APPLICATION NO.	FILING DATE	FIRST NAMED INVENTOR	ATTORNEY DOCKET NO.	CONFIRMATION NO.
10/565,982	01/26/2006	Melchor Daumal Castellon	001058-00031	9466
27557 7590 04/29/2008 BLANK ROME LLP 600 NEW HAMPSHIRE AVENUE, N.W. WASHINGTON, DC 20037				
EXAMINER				
DIAZ, THOMAS C				
ART UNIT		PAPER NUMBER		
4171				
MAIL DATE		DELIVERY MODE		
04/29/2008		PAPER

Office Action Summary**Application No.**

DETAILED ACTION

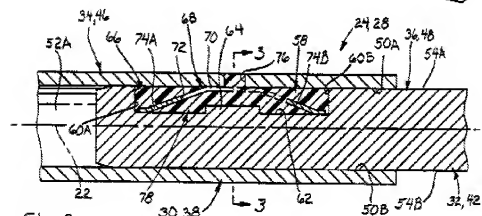
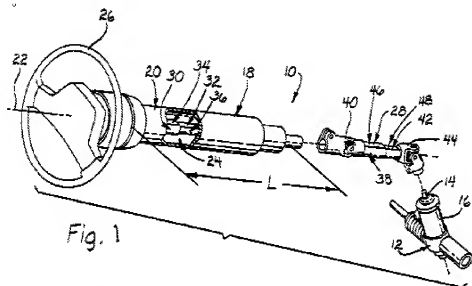
1. The drawings are objected to as failing to comply with 37 CFR 1.84(p)(4) because reference character “10” has been used to designate both a universal joint and a fastening cage recess. Corrected drawing sheets in compliance with 37 CFR 1.121(d) are required in reply to the Office action to avoid abandonment of the application. Any amended replacement drawing sheet should include all of the figures appearing on the immediate prior version of the sheet, even if only one figure is being amended. Each drawing sheet submitted after the filing date of an application must be labeled in the top margin as either “Replacement Sheet” or “New Sheet” pursuant to 37 CFR 1.121(d). If the changes are not accepted by the examiner, the applicant will be notified and informed of any required corrective action in the next Office action. The objection to the drawings will not be held in abeyance.

5. Claims 1-3 are rejected under 35 U.S.C. 102(b) as anticipated by or, in the alternative, under 35 U.S.C. 103(a) as obvious over Dykema et al. (US patent 5348345).
6. Applicant discloses an intermediate shaft for a steering assembly as seen below.

2. In addition to Replacement Sheets containing the corrected drawing figure(s), applicant is required to submit a marked-up copy of each Replacement Sheet including annotations indicating the changes made to the previous version. The marked-up copy must be clearly labeled as “Annotated Sheets” and must be presented in the amendment or remarks section that explains the change(s) to the drawings. See 37 CFR 1.121(d)(1). Failure to timely submit the proposed drawing and marked-up copy will result in the abandonment of the application.

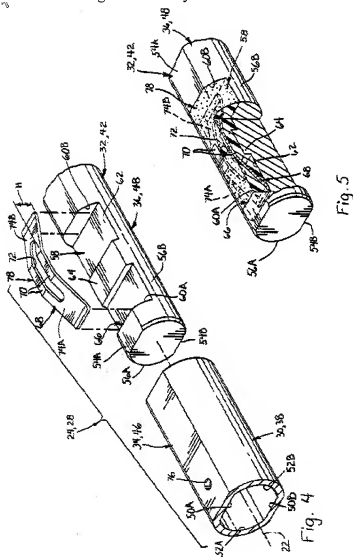
Dykema et al. teach a low sliding load intermediate shaft (col.1 line 66 to col. 2 line 7) in a motor vehicle steering column (col.1, lines 54-56). Dykema et al. discloses that the sliding members in the intermediate shaft have a minimized resistance to telescopic movement due to the low coefficient of friction in the interconnect between them. Dykema et al. further teaches a first member (fig. 2, 46) corresponding to applicants female member and a second member (fig. 2, 48) corresponding to the male member. A spring having an uneven contact surface (fig. 4, 68) corresponding to applicant's metal strips is placed inside the recess (fig.2, 58) wherein there is a fastening cage (fig. 2, 78) clamped to the external surface of the male member as seen in figure 2.

Dykema et al. further teaches that the said cage is fastened to the male member by means of deformations on the lateral surface which is seen in figure 4, 64. Additionally, the cage or plastic block is injected directly onto the surface of the male member as disclosed in col. 4, lines 38-42.

Figure 1a- Legend of MPEP materials

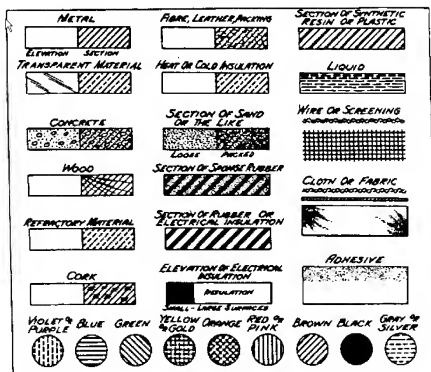
However, Section 608.2 of the MPEP depicts a legend for drawing symbols, seen below, such as the cross-hatching used in Dykema et al. in figure 5 (see below). Therefore, the examiner has reason to believe that the material taught by Dykema et al. for the spring would inherently be metal.
